## Sherwood Festival Plaza

DATE September 15, 2022

## ADDENDUM NO. 1

### Addition/Change to the Contract Documents

SHEET TITLE  
**ELECTRICAL ONE-LINE DIAGRAM AND SCHEDULES**

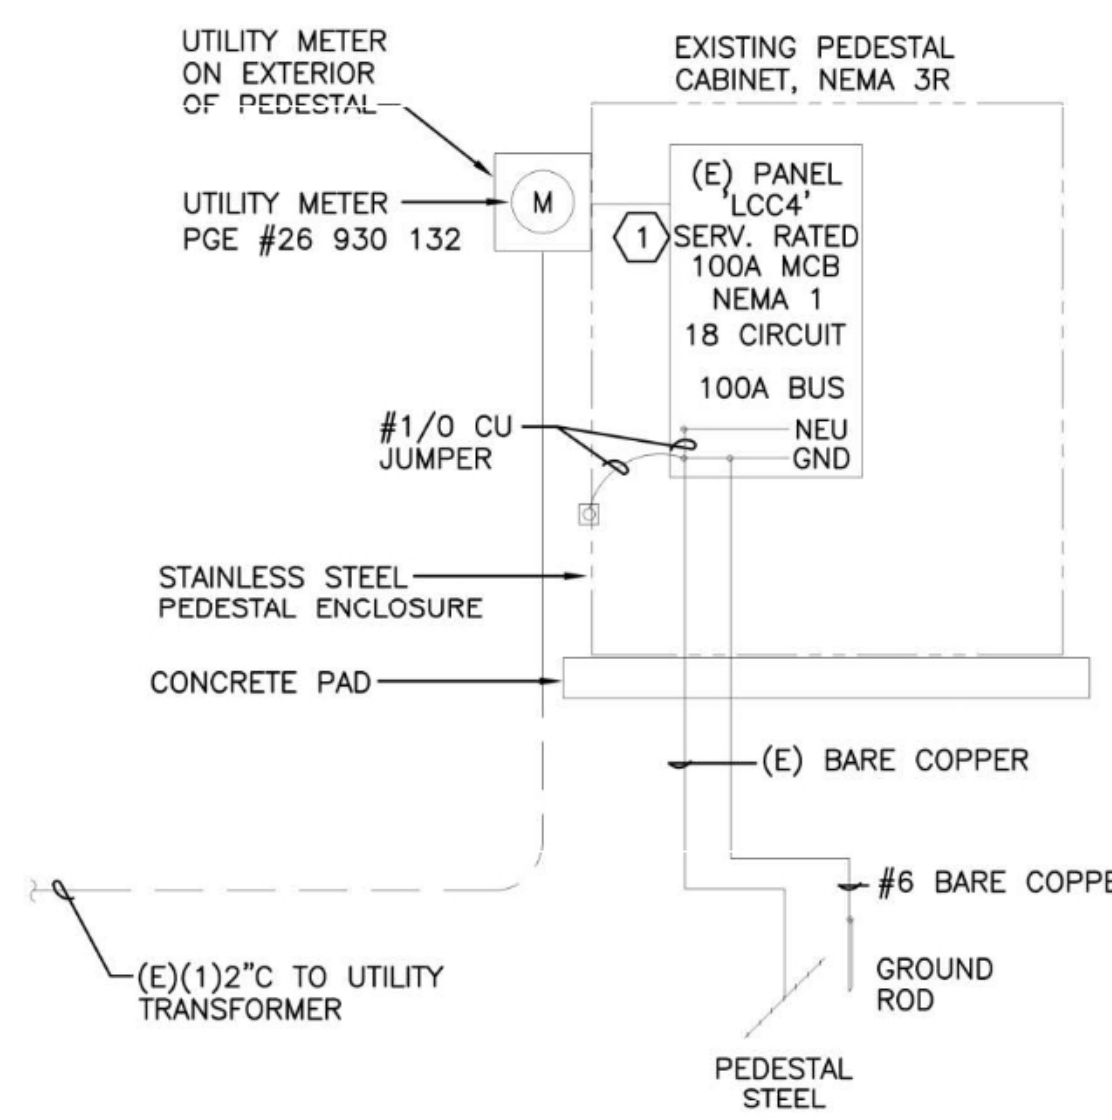
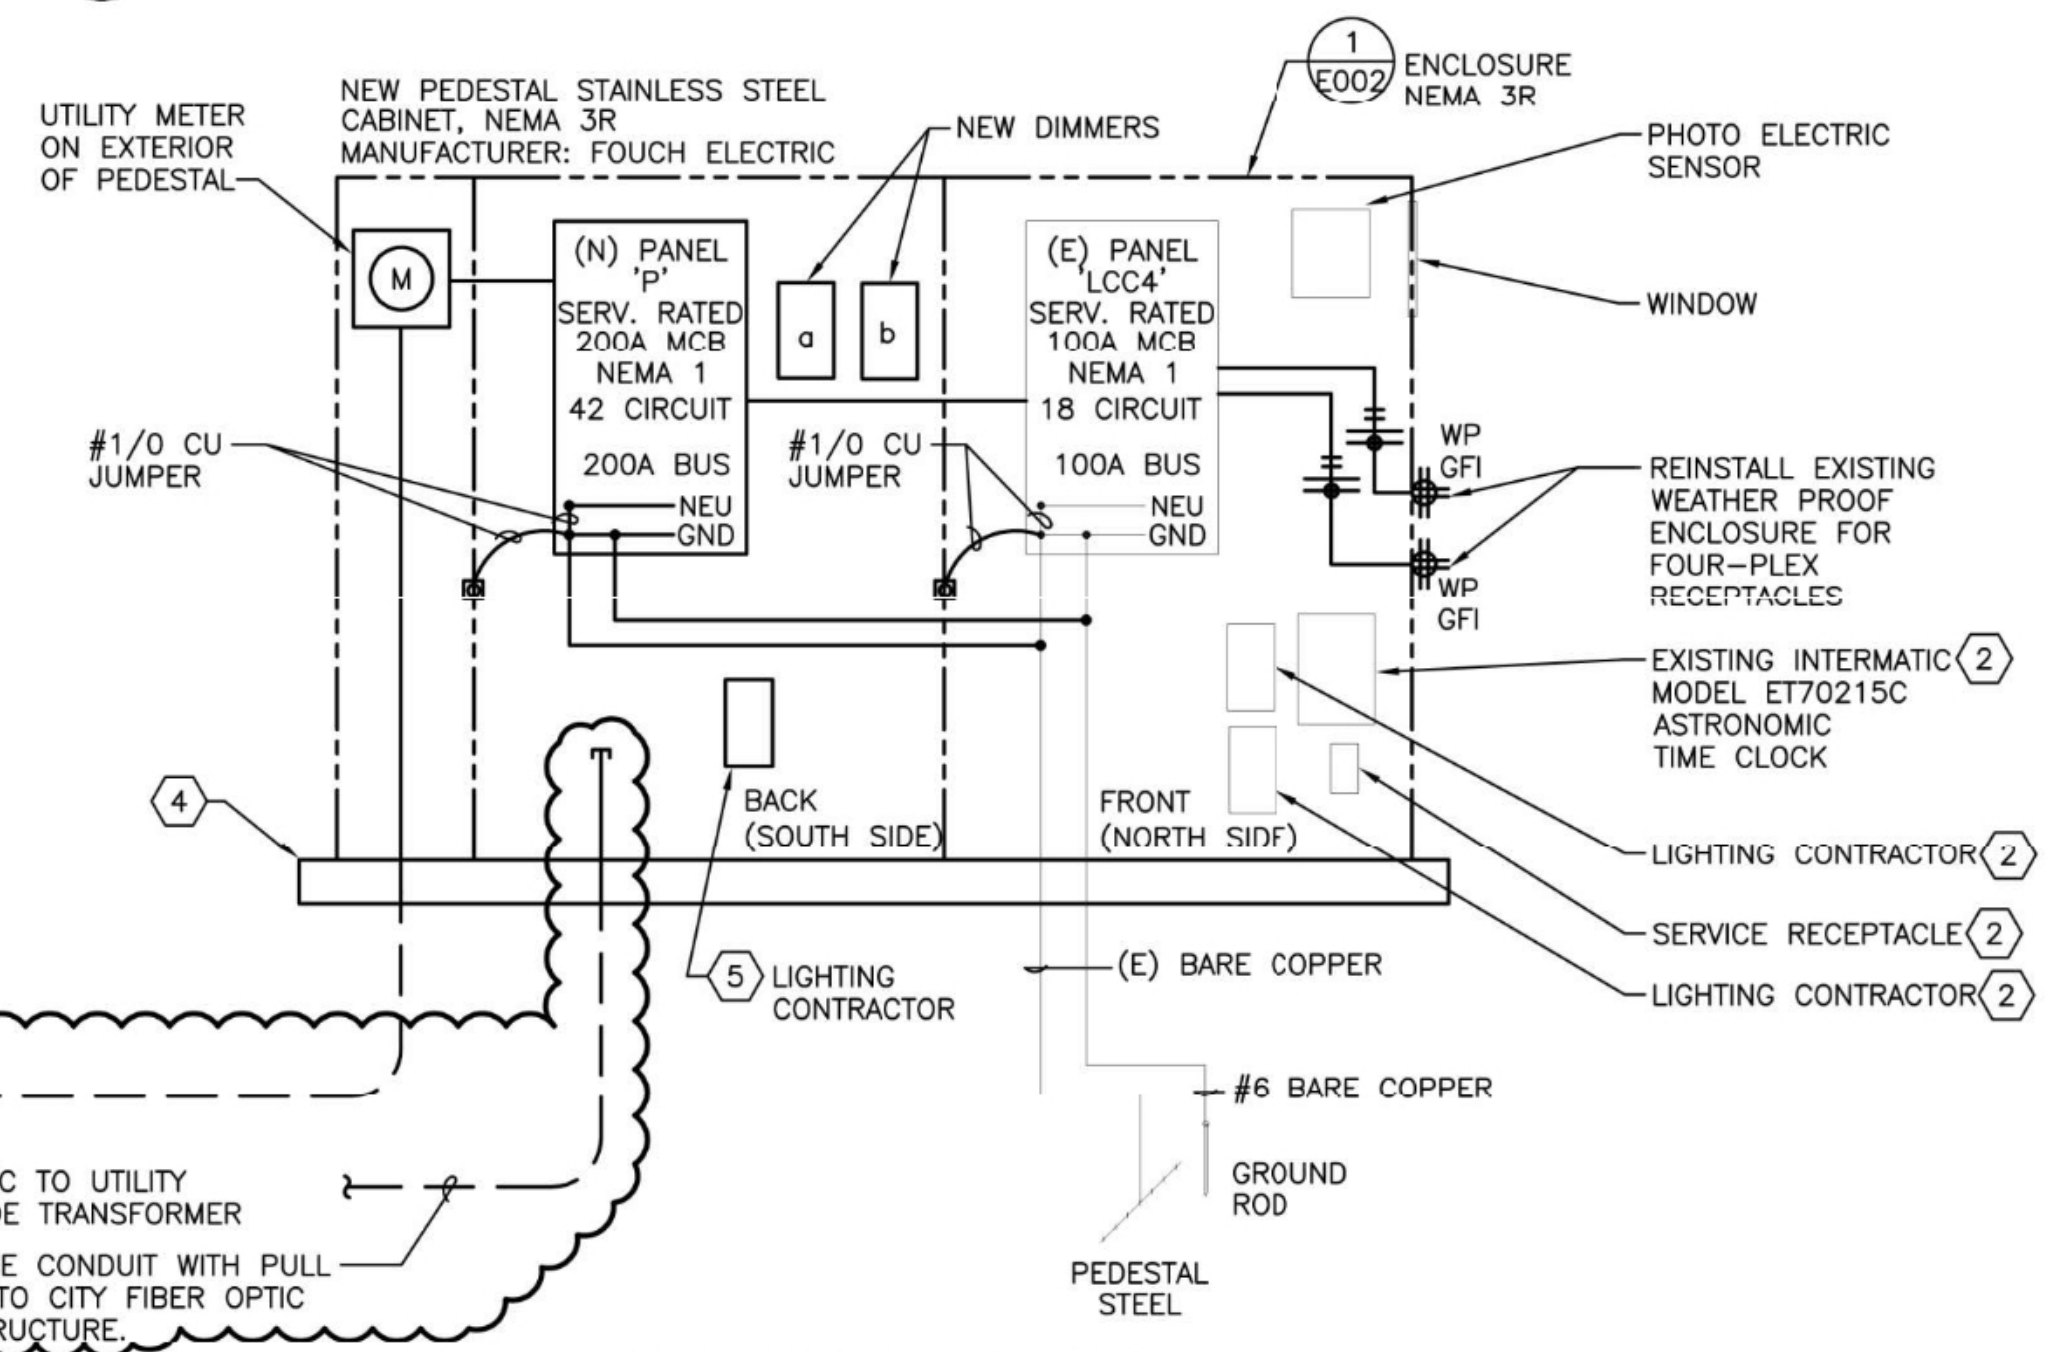
**Question 8:** Sheet #002 keynote #6 also mentions an ethernet device/patch panel. Could more information be provided about the Fiber scope?

**Answer 8:** Fiber optic cable to terminate at irrigation controller. No separate patch panel will be required.

SITE PLAN - ELECTRICAL

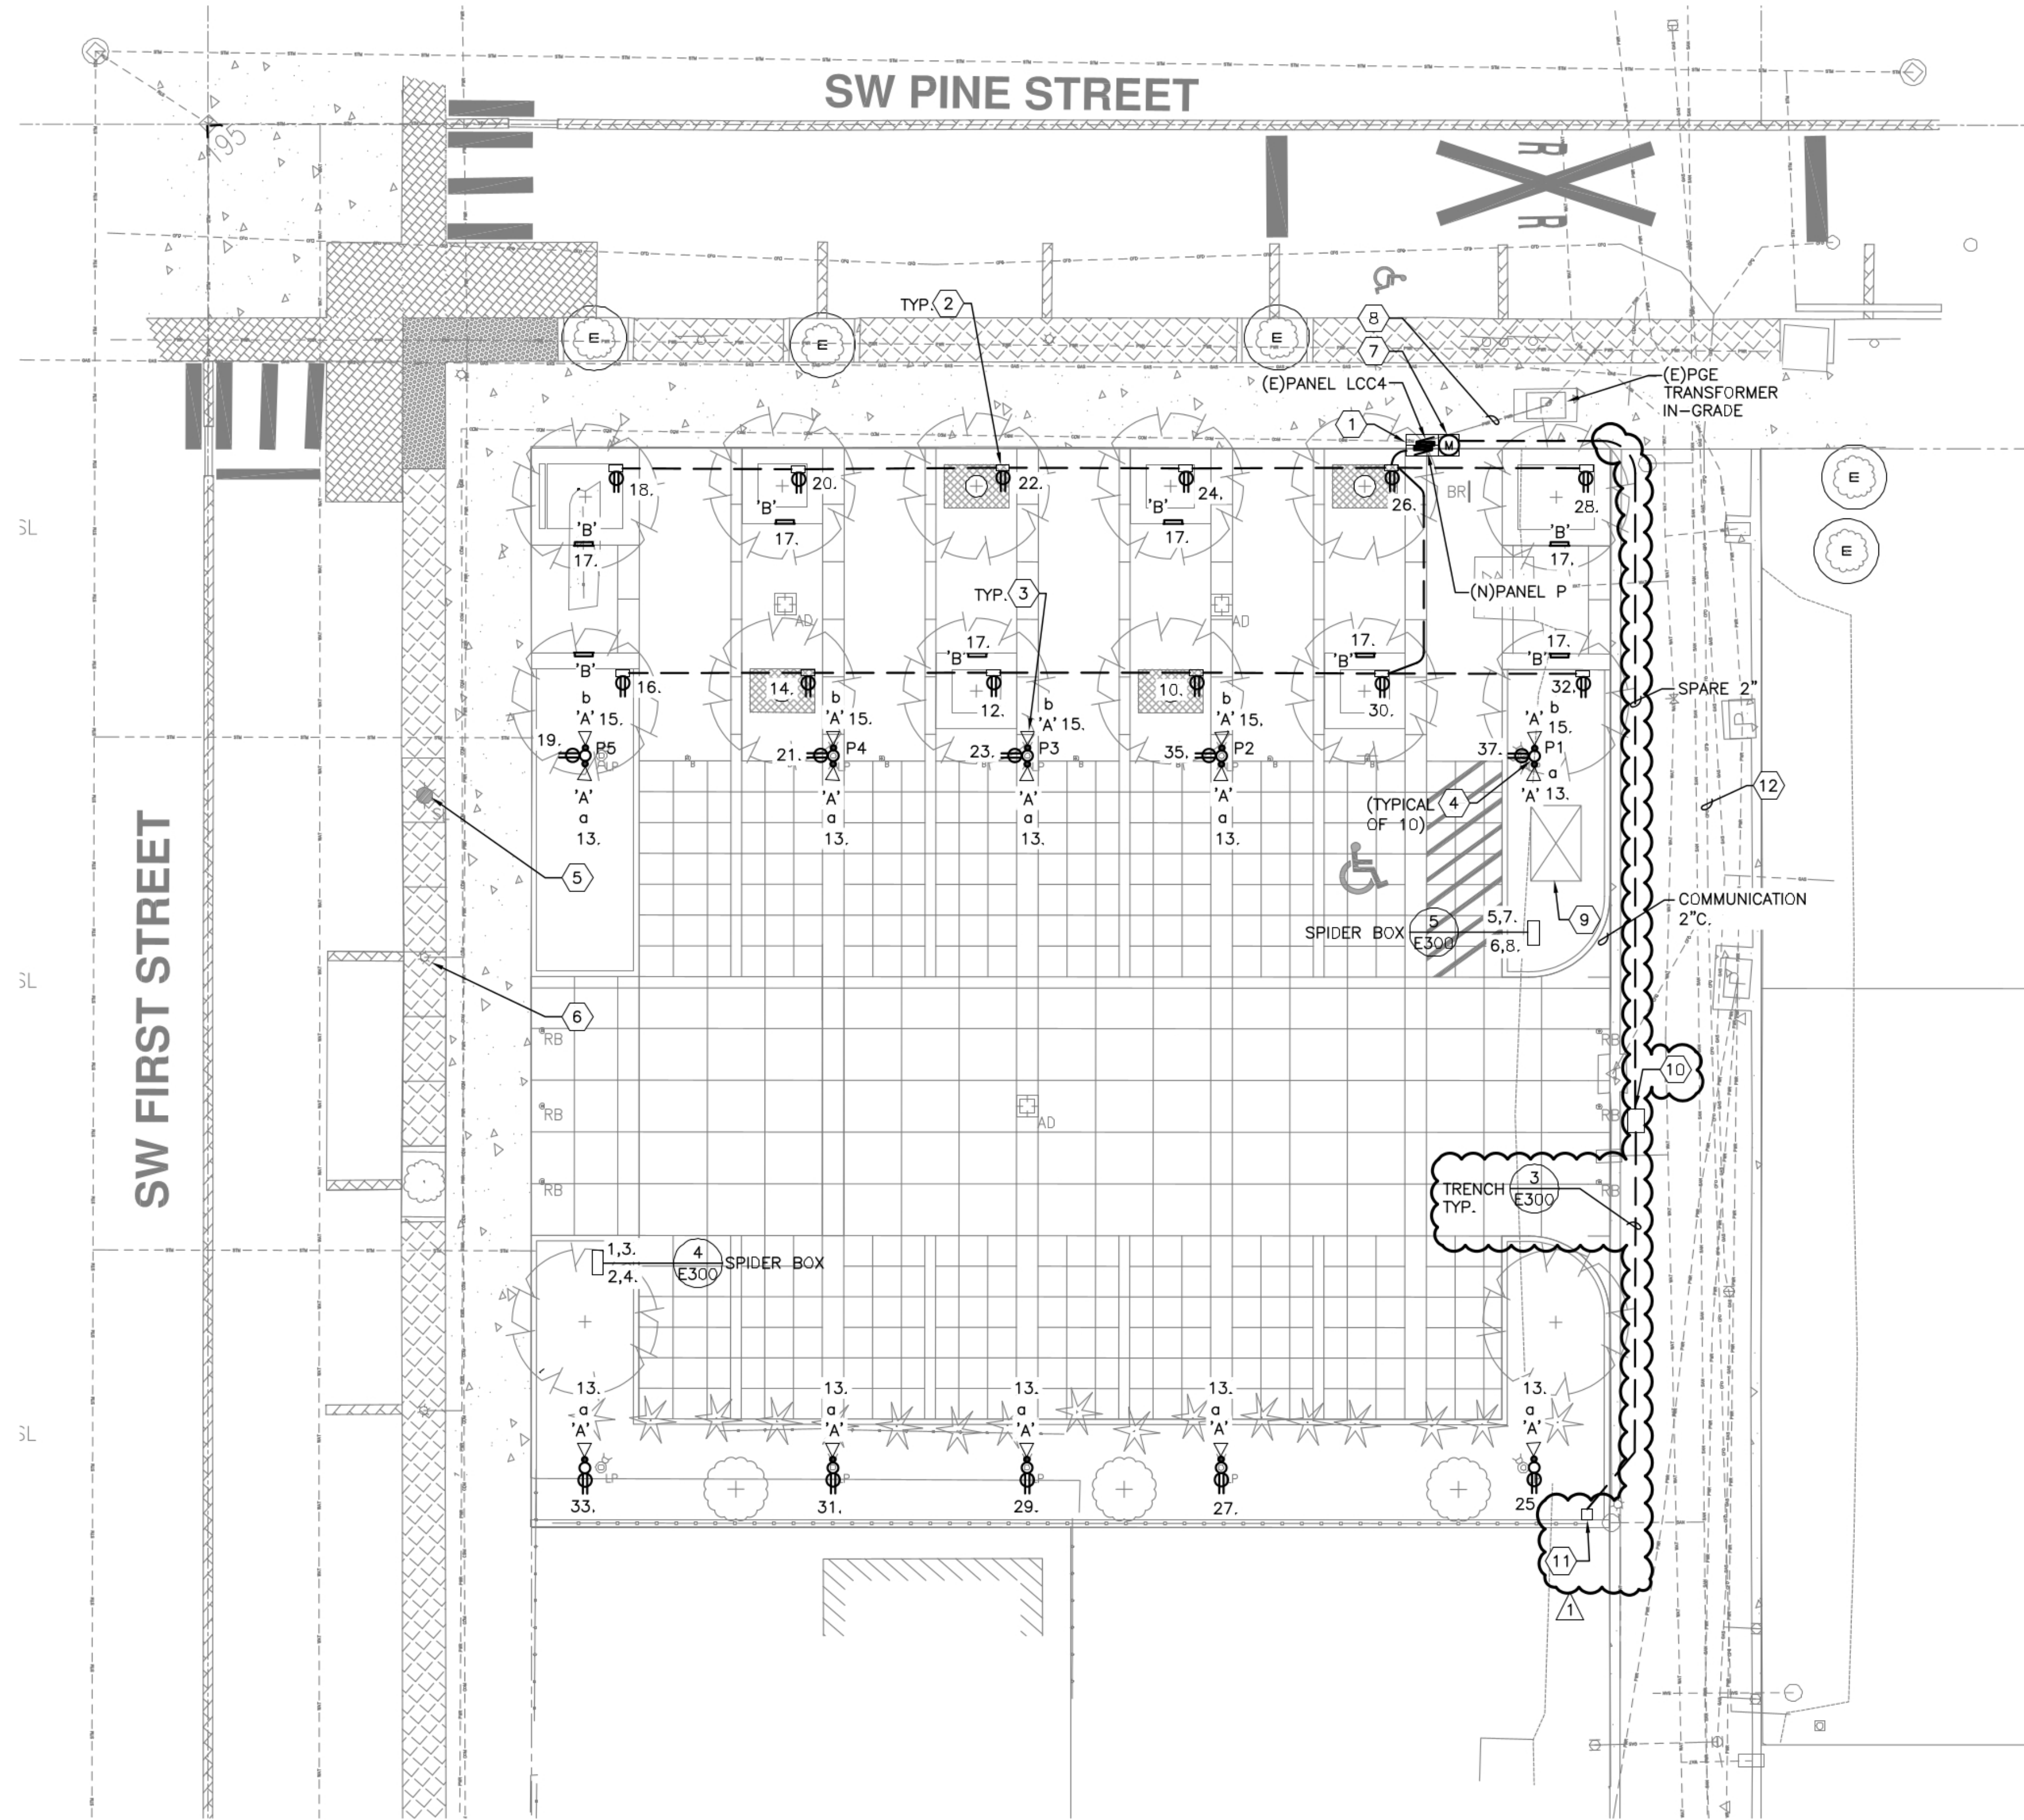
**Question 5:** Sheet E100 keynote #10 shows intercepting the City Fiber Infrastructure. Question: Is there a Fiber Vault with a fiber loop in it at this location?

**Question 6:** If this is just a conduit containing a Fiber how do we splice into it?

**Answer 3:** Tree well receptacles have been moved to the Northeast corner of the well boxes. The conduit will be routed across the north side of the tree boxes.

**Answer 5:** Electrical plans have been updated to show the location of the existing fiber vault.

**Answer 6:** Electrical plans have been updated to show (2) new 2" HDPE conduits to be routed from the City's existing fiber vault. One conduit will go to the irrigation controller and the second will be a spare conduit to the service panel.
